| RE: | New Beaverton Middle School at Timberland |

| Addendum Number | Date | Description |
|-----------------|---------|-----------------------------------------------------------------------------|
| 1 | 7/23/15 | Geotechnical Engineering Services - Seismic Peer Review Comments (attached) |

Addendum 1
Seismic Peer Review Comments
New Beaverton Middle School at Timberland
NW 118th Avenue and NW Stone Mountain Lane
Beaverton, Oregon
GeoDesign Project: BeavSchool-45-01

RE: Code Review—Seismic Site Hazard Report
PWI Project #22128.03
Contract #1600564

ADDITIONAL SUBSURFACE INFORMATION ASSOCIATED WITH THE TIMBERLAND AREA

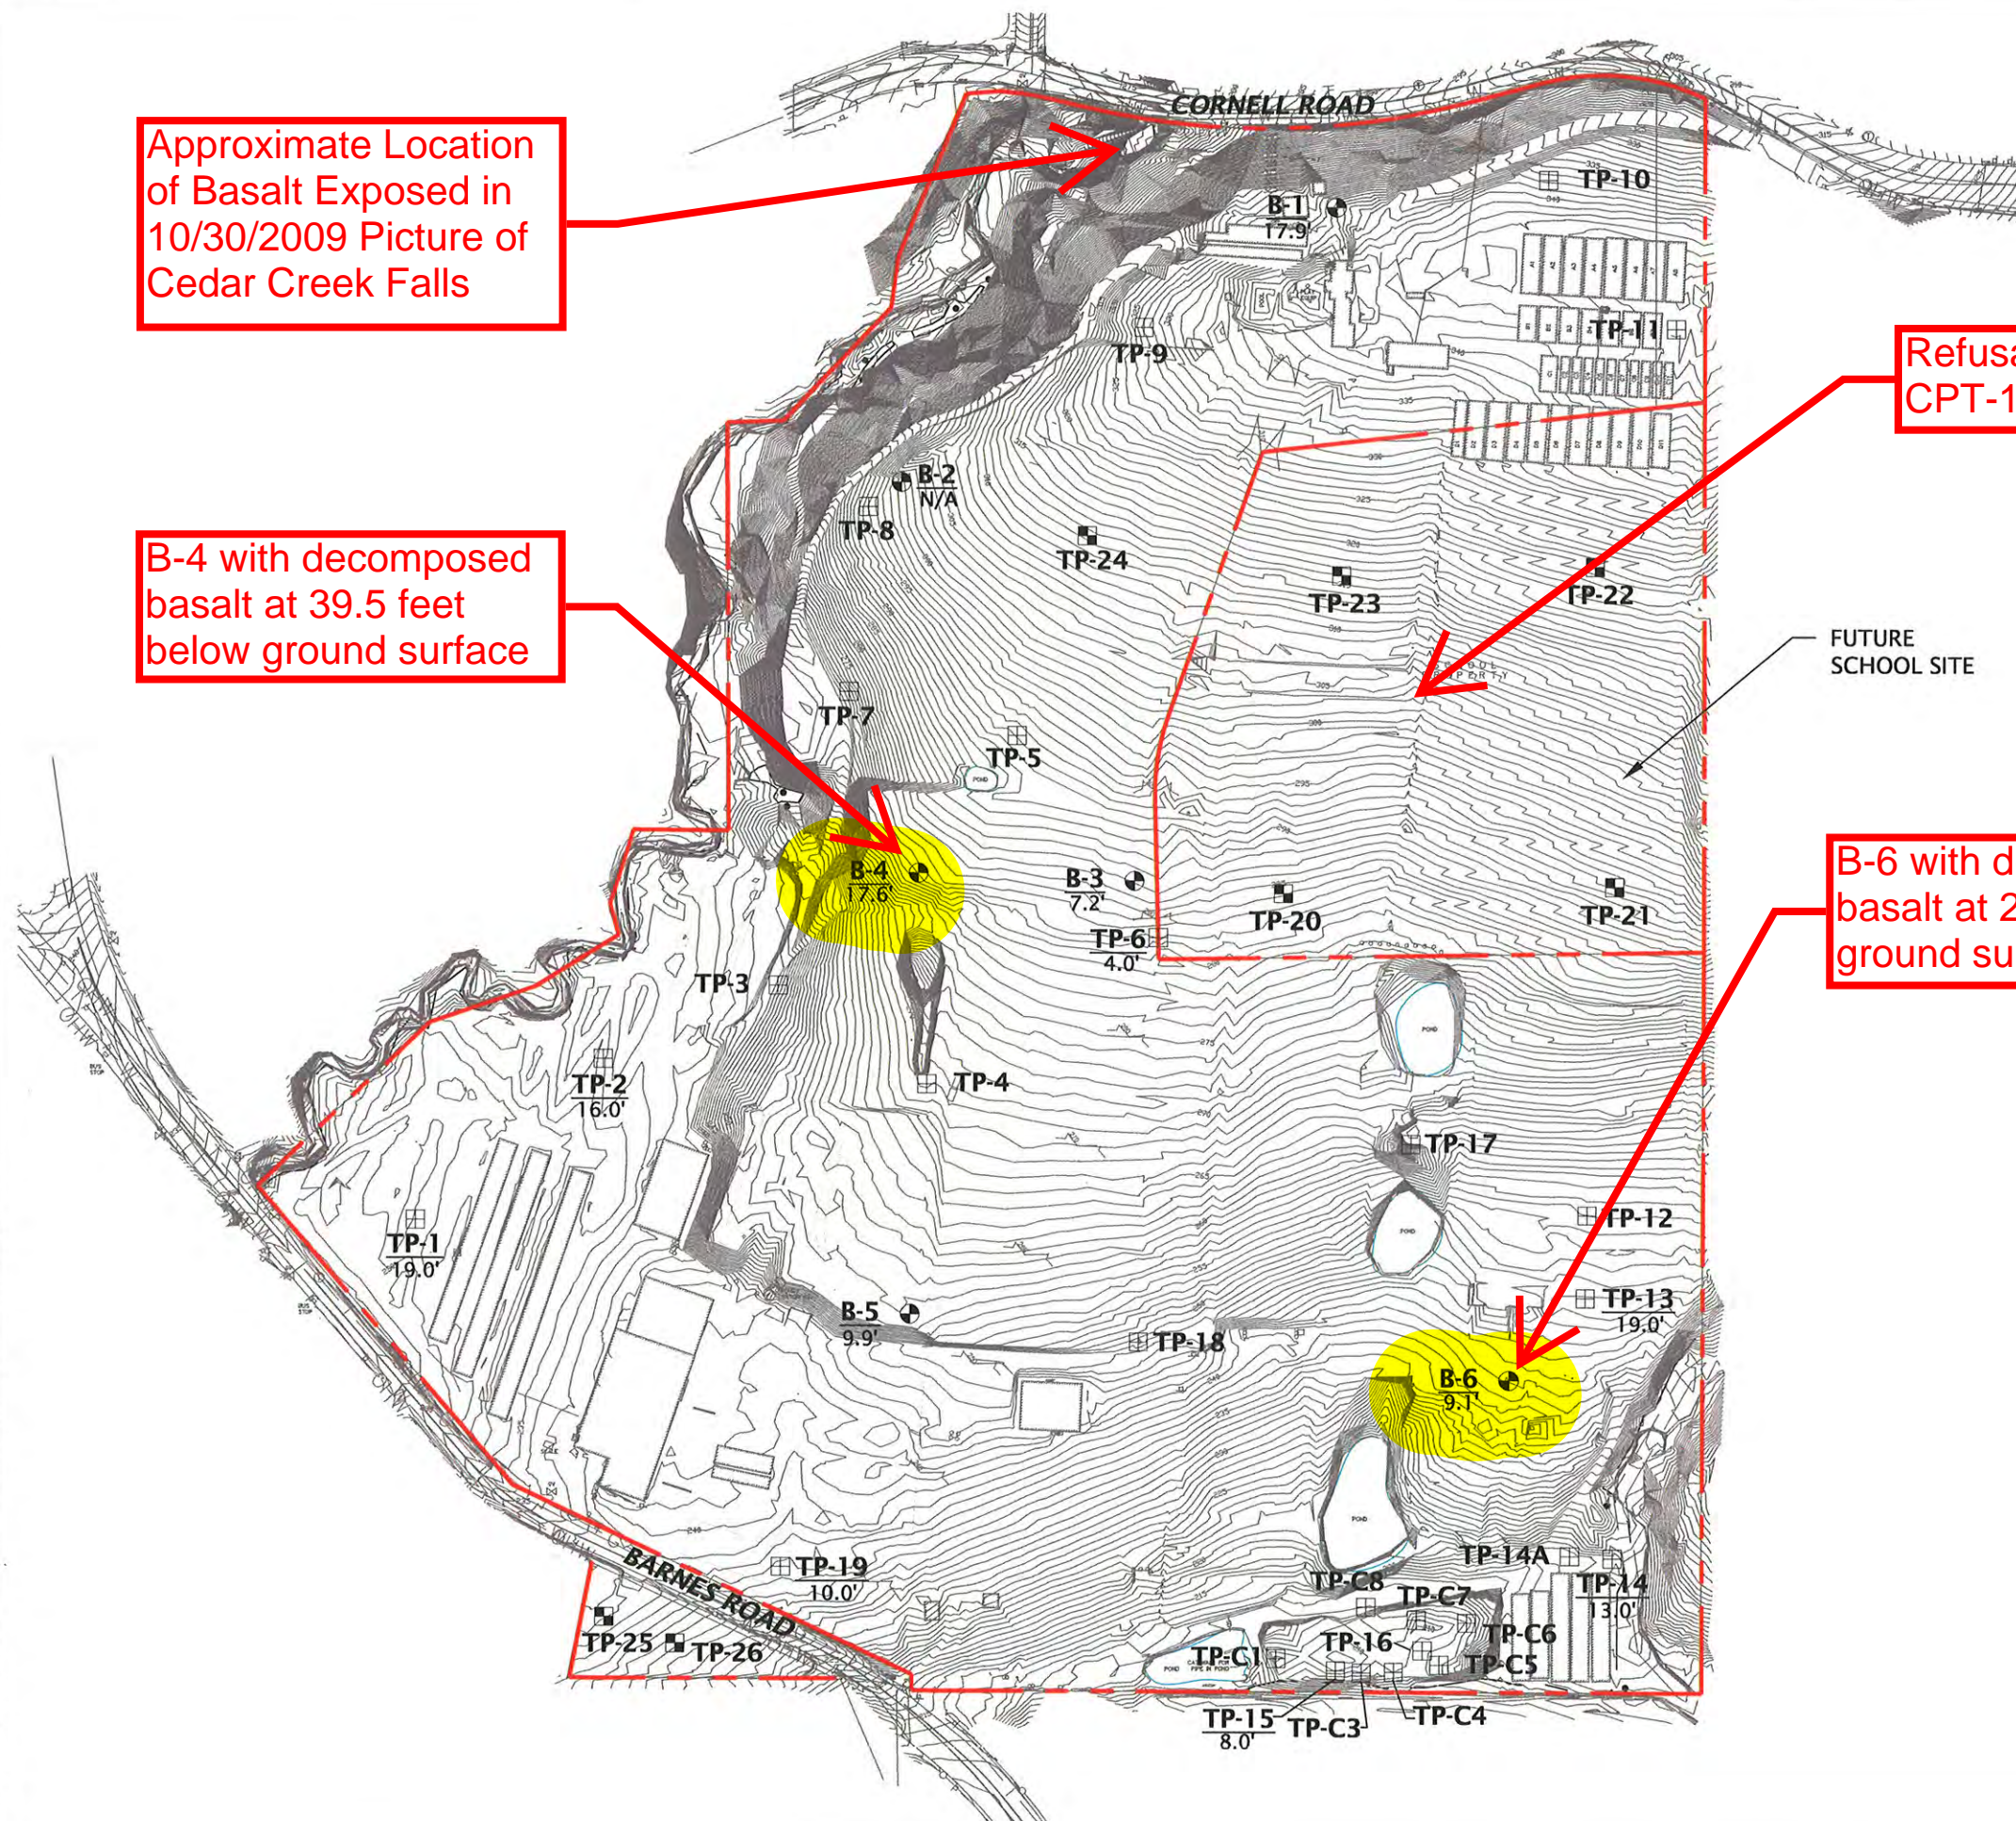
a. The GeoDesign report inferred the geologic profile of the site by interpretation of a single hole, the CPT probe, which hole is located near

The underlying basalt contact was inferred at elevation +/- 260 from practical refusal of the CPT probe; however, the CPT probe could have also refused advancement on a rock or woody material fragment as encountered in other holes.

- b. Considering that no other test borings were advanced to the bedrock contact, we are unable to conclude that the geologic profile is as interpreted from the CPT test. This test appears to be simply be one point on a line.

As discussed in the "Background" section of our report, GeoDesign has extensive experience on the school site and the surrounding areas of the Timberland development dating back to 2004. Attachment B includes a former site plan for the Timberland area, which shows the location of two past borings (B-4 and B-6) in which basalt or decomposed basalt was encountered at depths of 29 to 39.5 feet below ground surface. On the site plan we have also noted the approximate location of a picture taken at the base of Cedar Creek where basalt is exposed. The associated site plans and referenced boring logs are presented in Attachment B.

In our opinion, and as stated in our geotechnical report, the refusal encountered in CPT-1 is interpreted to be the depth to weathered basalt rock at the approximate center of the Timberland site.
